New Albany Architectural Review Board Meeting Agenda
Monday, September 14, 2026, 7:00 p.m.

ARB-57-2026 Englefield Oil Signage Certificate of Appropriateness and Waivers

ARB-59-2026 Infinite Church Certificate of Appropriateness

ARB-61-2026 Athletic Campus Certificate of Appropriateness

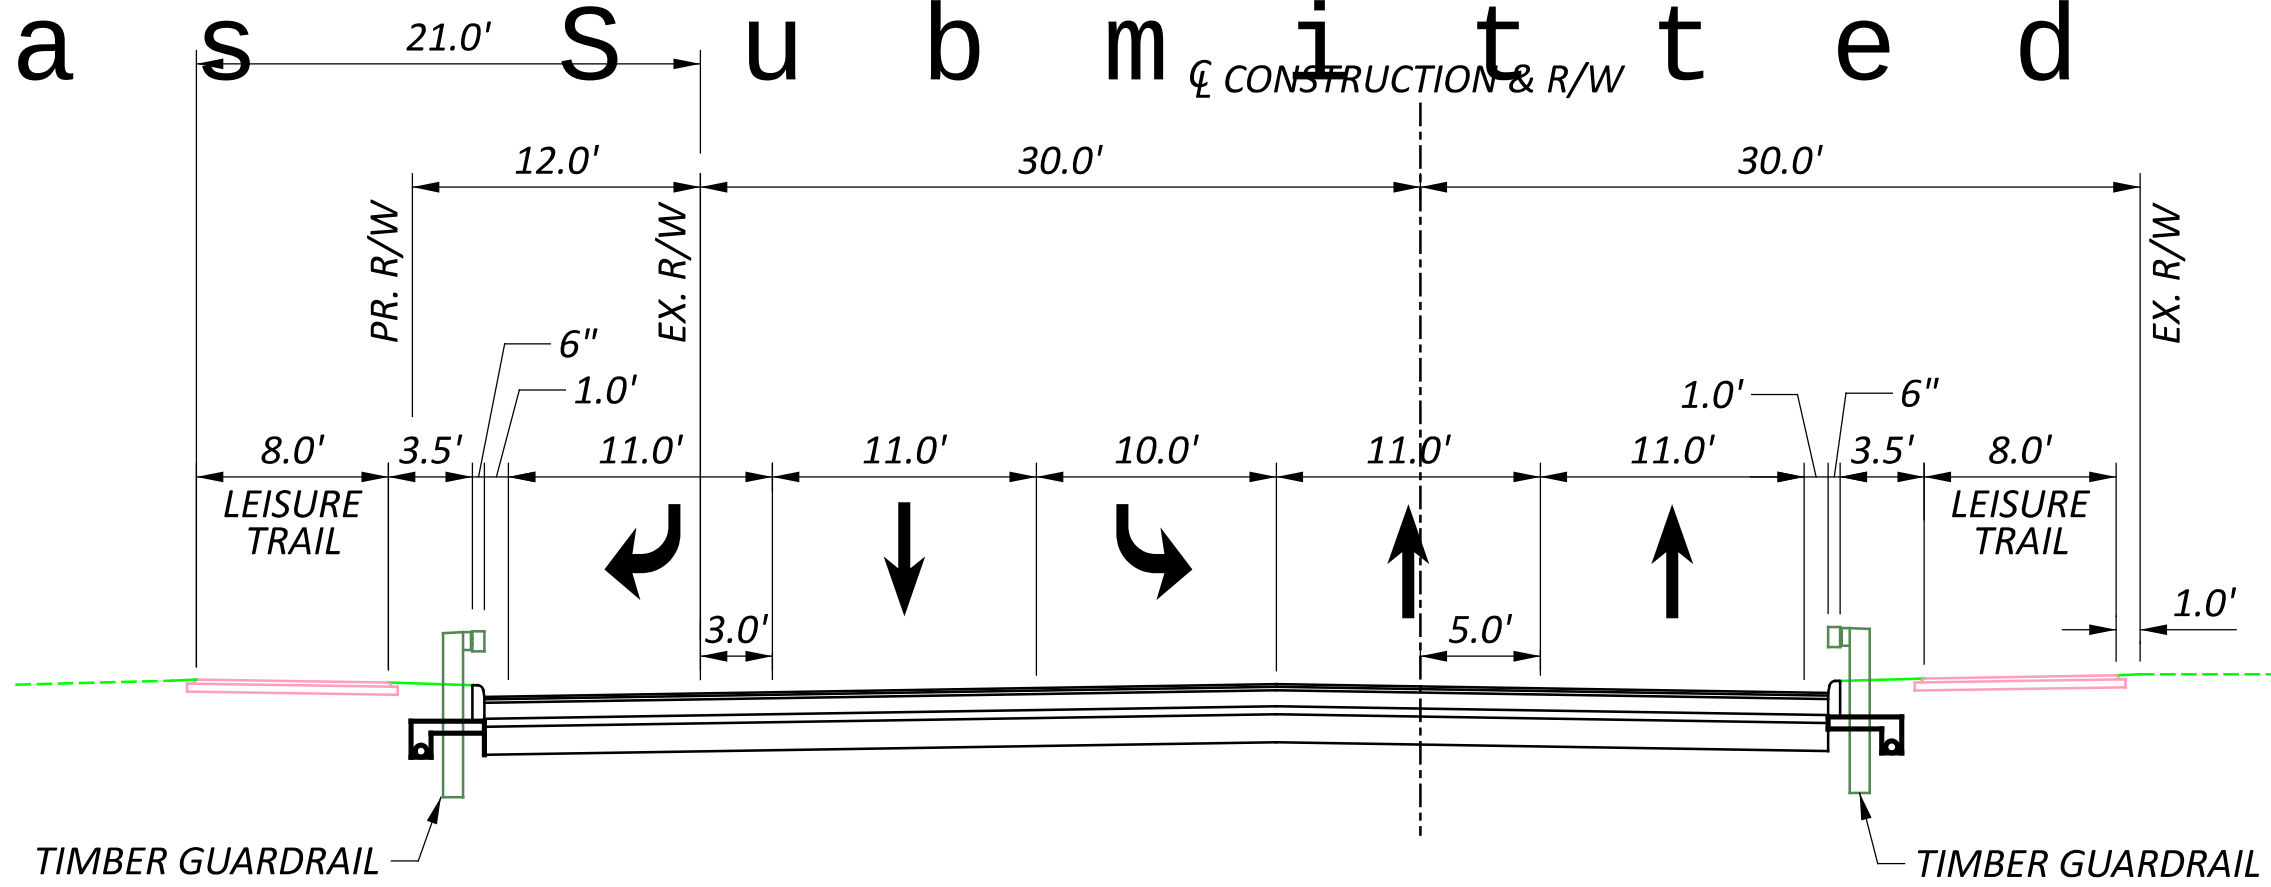
The city street improvement project requires the demolition and replacement of the existing gas price monument sign. All of the streetscape elements (including signage) will look the same as it does now. All of the streetscape elements are sliding back 10+/- feet into the site to accommodate a new right turn lane on Ganton Parkway.

Since the sign location is changing and this is a new sign, a certificate of appropriateness is required. There are two waivers being requested:

1. Waiver to zoning code section 3e.06(8)(f) to allow ground mounted signage to be free standing where the zoning text requires all ground mounted signage to be incorporated into the horse fence.
2. Waiver to zoning code section 3e.06(8)(h) to allow four colors to be used on a sign where the zoning text permits a maximum of three colors.

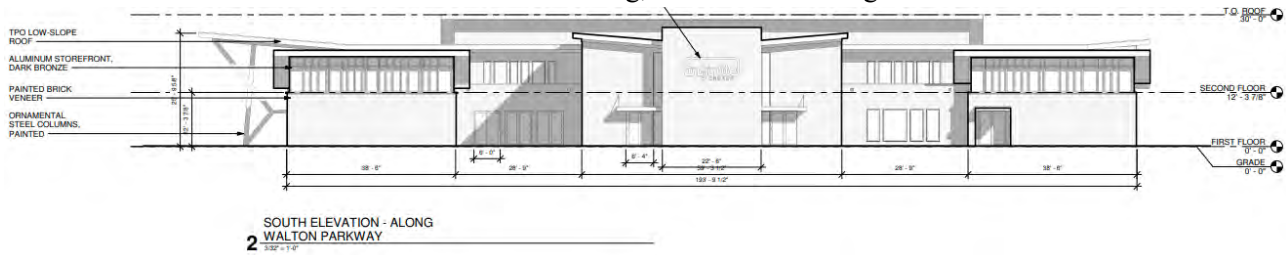
- Section 8(III.3) of the Design Guidelines & Requirements (DGRS) In keeping with traditional practice, the entrances to civic and institutional buildings shall be oriented toward primary streets and roads and shall be of a distinctive character that makes them easy to locate. Embraces shall be scaled and detailed to match the scale and detail of interior public space.

- o The proposed design provides entrances along Walton Parkway that are easy to locate on the building, as seen in the image below.

- o The main entrances are on the sides of the building where the awnings are and allow for more direct access from the parking lot.
 - Section 8(III.4) of the Design Guidelines & Requirements (DGRS) Civic and institutional designs shall follow the precedents of traditional American architectural designs, with particular care paid to the proportions of wall height to width; roof shape; and proportions of windows and doors, including vertically-proportioned window panes. The details and design characteristics of the traditional style selected for a new building shall be carefully studied and faithfully rendered in the new building's design.
